Access Compliance Report

Public Rights-of-Way

(Curb Ramps)

| Intersection ID: 3831 | Main Street: MALLARD_DR | Cross Street: SAXONBURY_WY | Location: | E |

| ADA ID: B0943AA7BE5E | Ramp Type: Perp | Initial Pass/Fail: Fail | Overall Compliance: No | Severity Score: 22.5 |

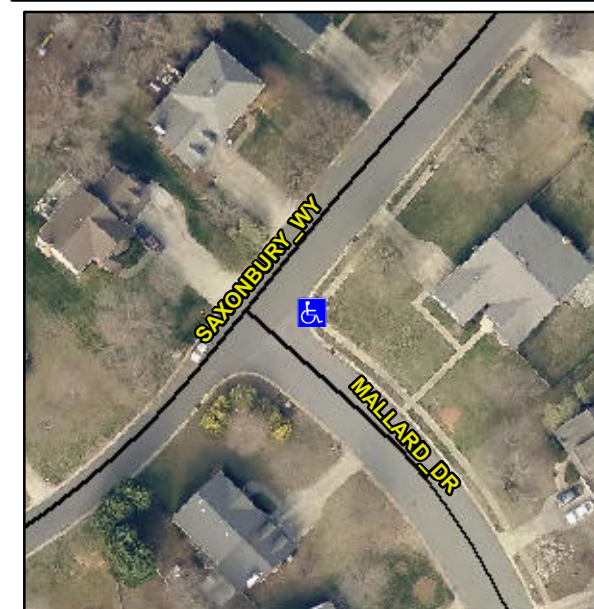
Not Found, R304.5.1, R304.2.2, R304.5.3

| Compliance | Description | Data | Compliance | Description | Data |
|------------|-----------------------|-------|------------|-----------------------------|------|
| N/A | Ramp Length (in) | 61.0 | No | Ramp Slope (%) | 9.9 |
| No | Ramp Width (in) | 40.5 | No | Ramp XSlope (%) | 4.7 |

Remove & Replace Entire Ramp.
